UNITED STATES
NUCLEAR REGULATORY COMMISSION
WASHINGTON, D.C. 20555-0001

SUBJECT: TECHNICAL REVIEW OF QUALITY ASSURANCE
DOCUMENTATION FOR THE CEMENTITIOUS BARRIERS
PARTNERSHIP TOOLBOX (DOCKET NO. PROJ0734)

Technical Review of Quality Assurance Documentation for the Cementitious Barriers Partnership Toolbox

Figure 3. Overview of the CBP Software QA Status

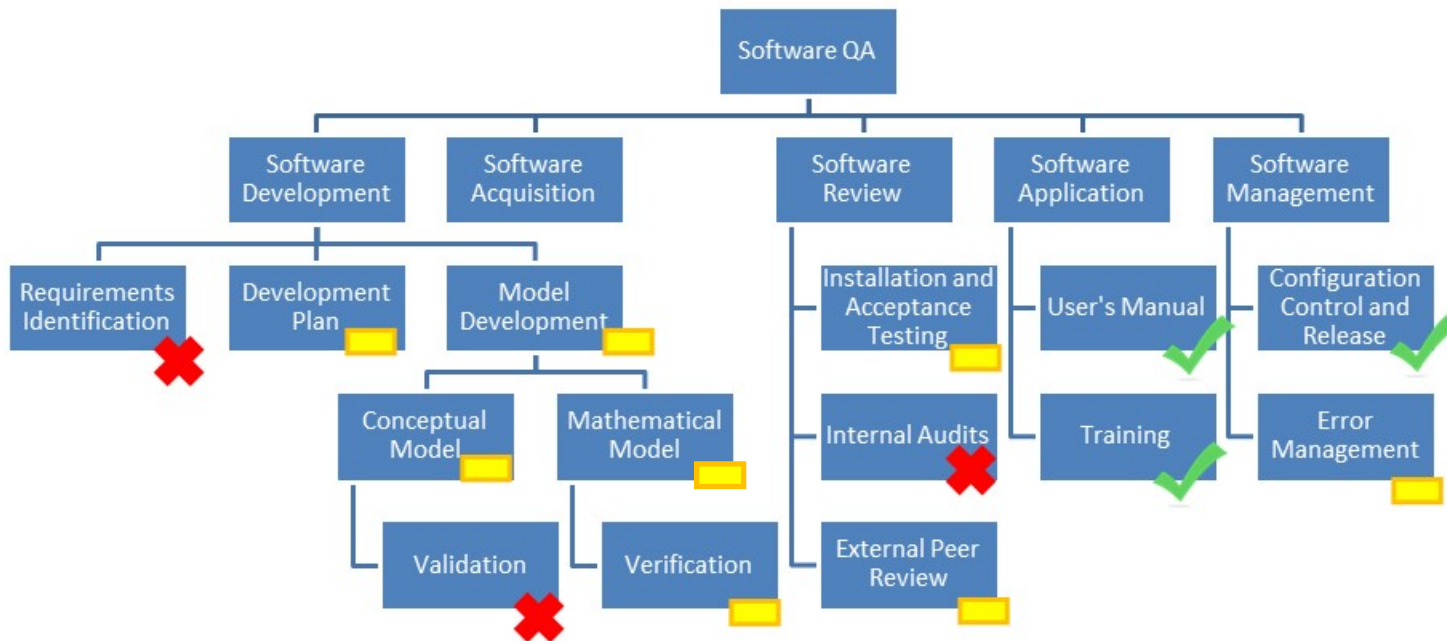
Figure 3 summarizes the NRC's overall summary of the CBP QA program. The green check means essentially completed or generally sufficient, the yellow dash means partially completed or improvement needed, whereas the red X means not completed or insufficient. These high level subjective ratings are essentially an average over all CBP components. For a more in-depth discussion of each individual component, see the sub-sections that follow. Because an NRC staff gave an element a check does not mean that there are not areas of improvement. Likewise because NRC staff gave an element an X does not mean that it is totally deficient.

The NRC staff is trying to present in a clear manner those areas that need the most effort to achieve a level of software QA as recommended in the implementing procedure. Because most of the responsibility for software QA was delegated to the PI's organizations, there is variability from organization to organization.
